# AGENDA

ARCHITECTURAL REVIEW BOARD MEETING  
CITY HALL, 385 SOUTH GOLIAD STREET, ROCKWALL, TEXAS  
MAY 26, 2026 IN THE CITY COUNCIL CONFERENCE ROOM AT 5:00 PM

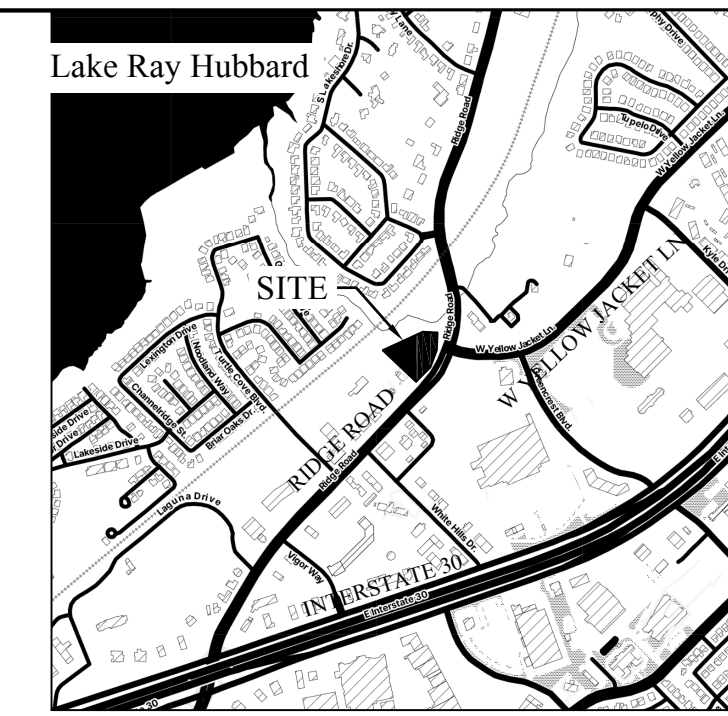
B+A Architecture's response: At this time of the submittal, we are only requesting for (1) variance of the #4 - Primary Articulation on all sides of the building
